Addendum No.1
to
CONSTRUCTION DOCUMENTS
for

May 21, 2025
2023159.00

NCISD New District Administration Building
21330 Valley Ranch Parkway
New Caney, TX. 77357
May 20, 2025

S205

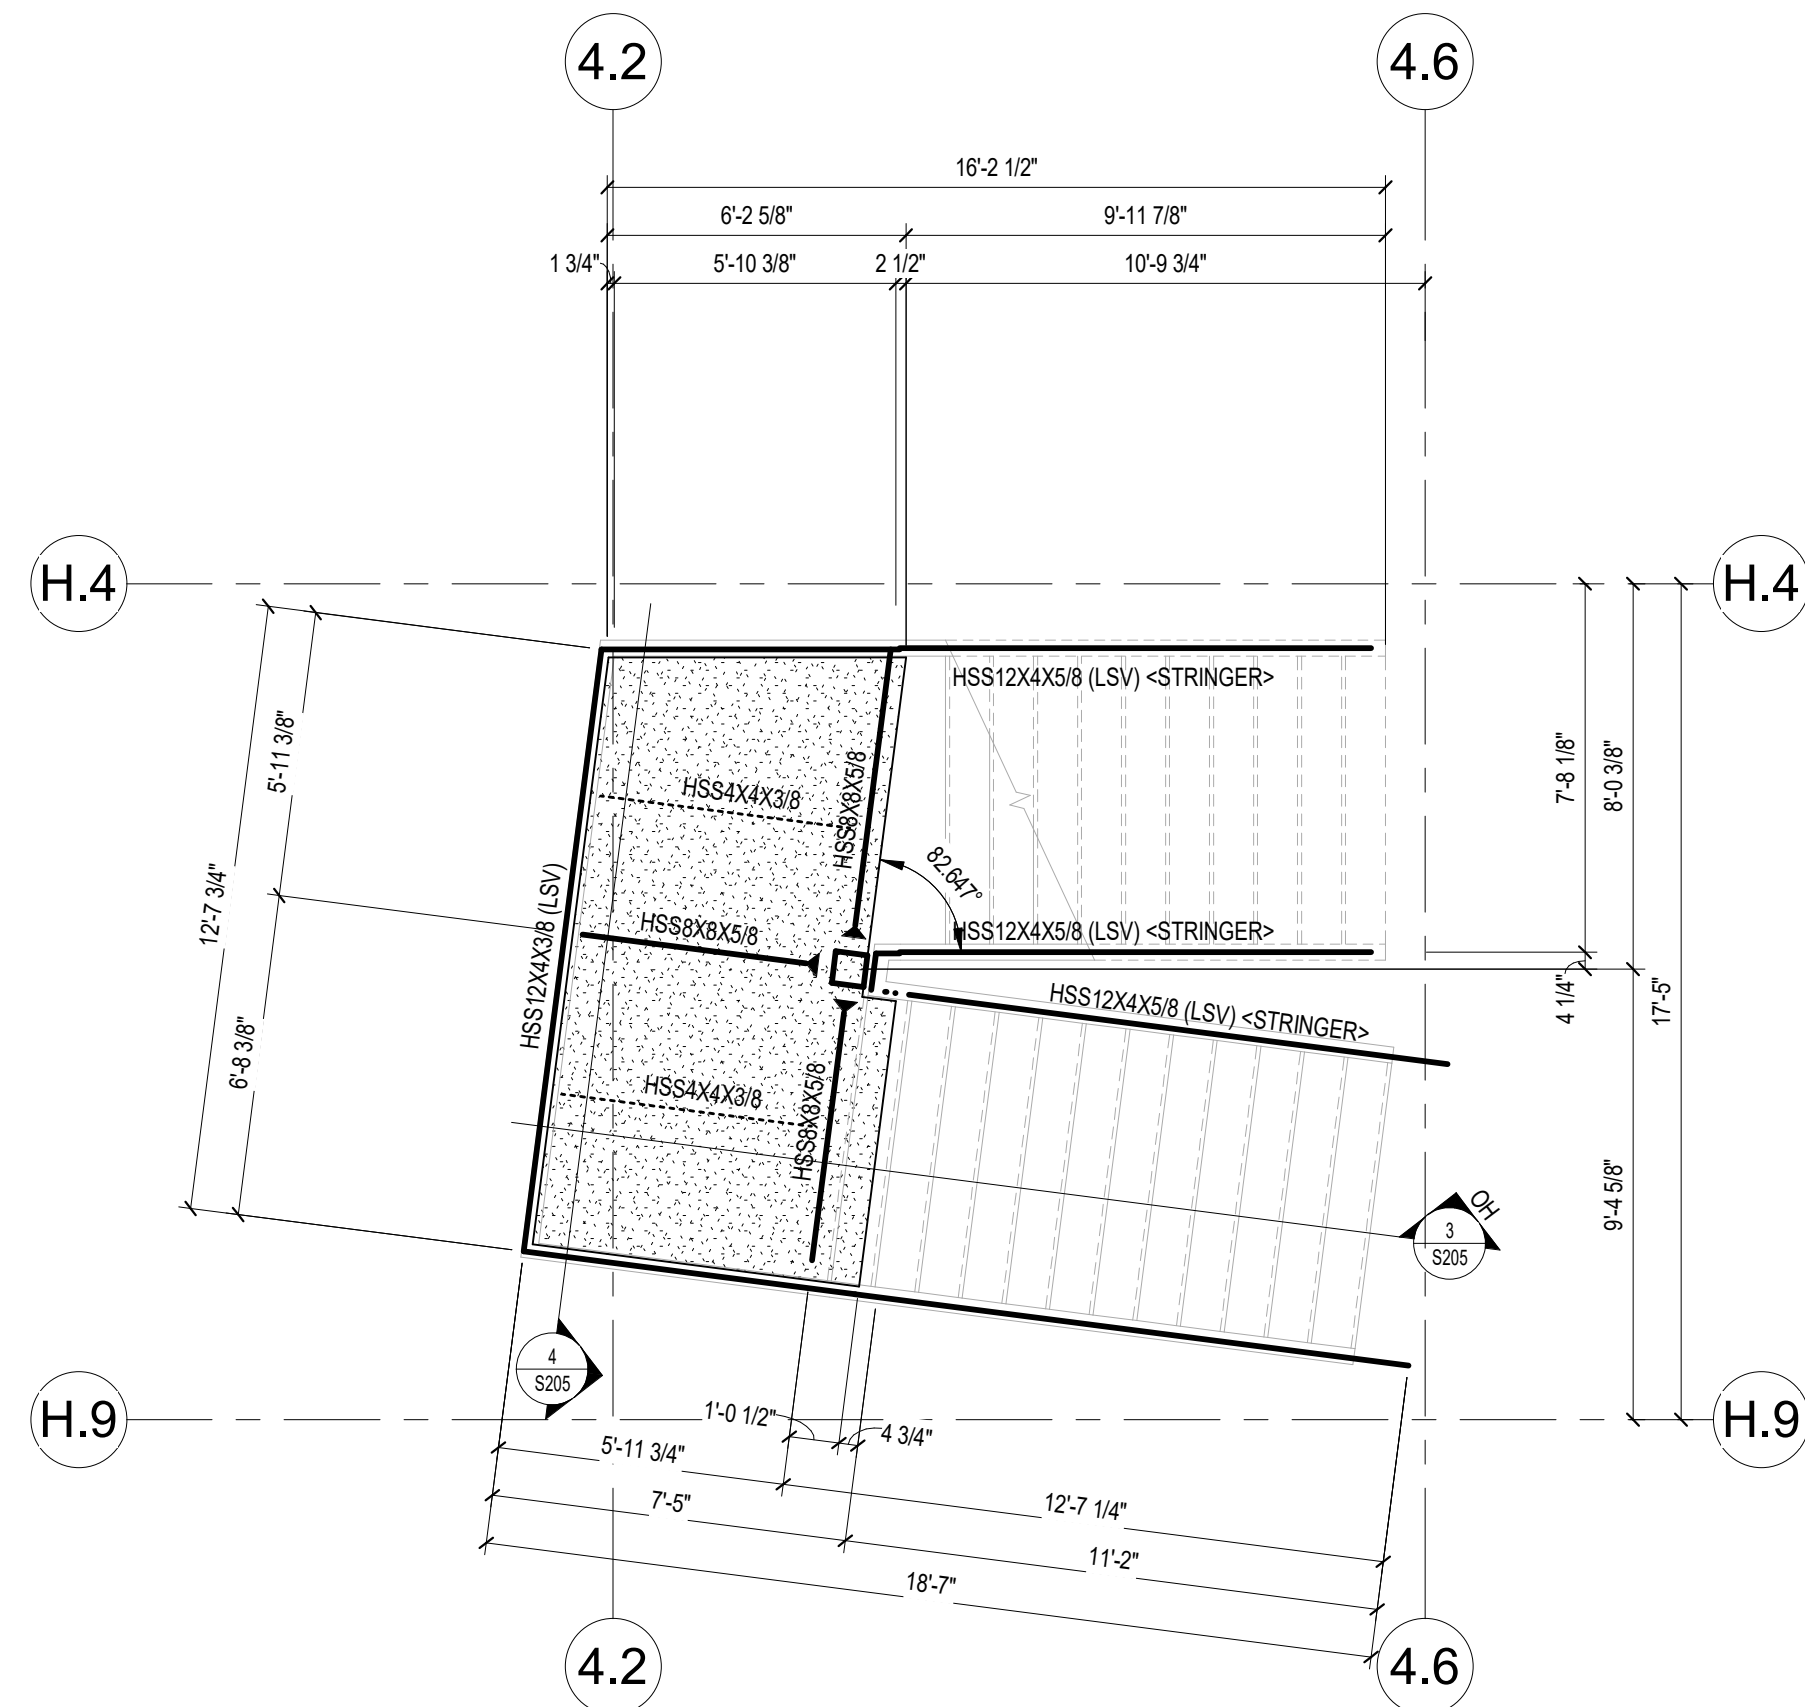
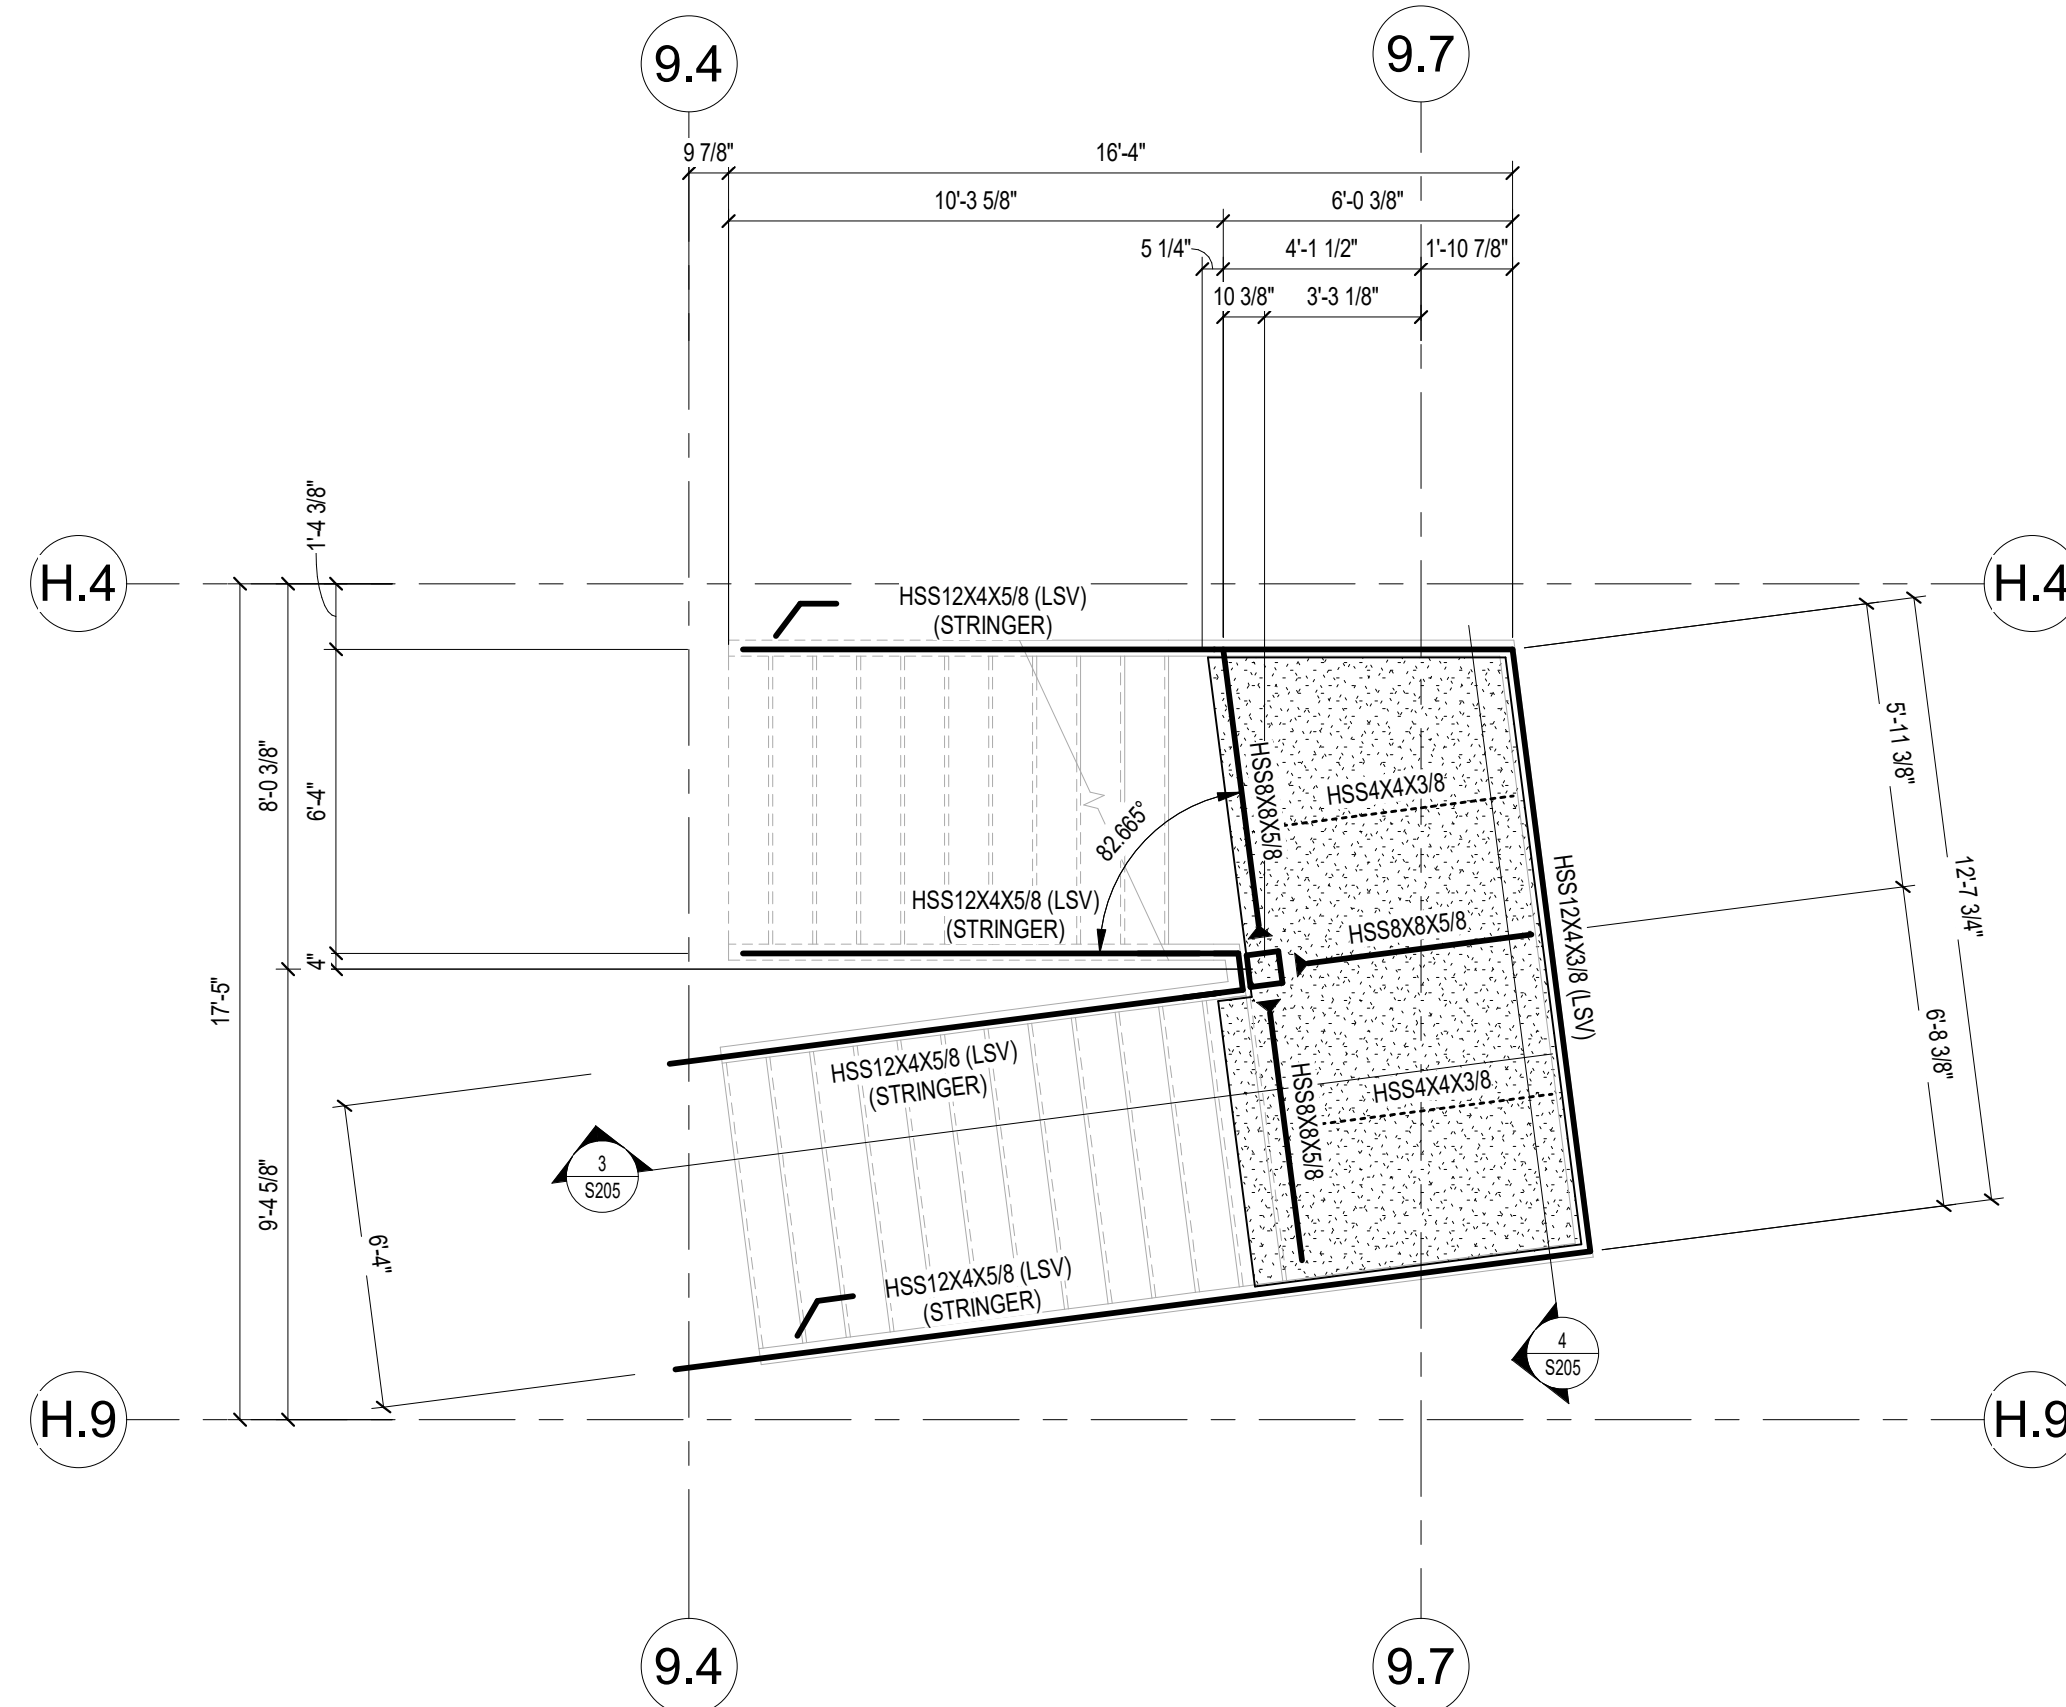
Item No. 10 **Sheet S205:**

- a) Delegated Design clarification comment added.
